Product Change Notice

PCN#: EE-PCN23011

May 23, 2023

FP0404R1-R022-R
FP0404R1-R065-R
FP0404R1-R080-R
FP0404R1-R100-R
FP0404R1-R110-R
FP0404R1-R170-R

For (R065 & R080 & R100 & R110 & R170)-R Only

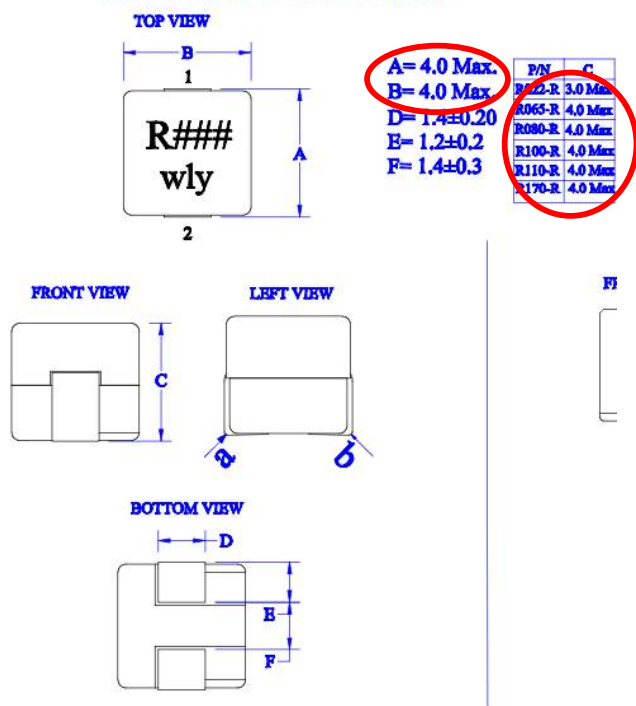
Update the FP0404R1-R datasheet to more accurately reflect dimensional measurement on the drawing by depicting measurements with tolerances rather than maximum measurements without tolerances.
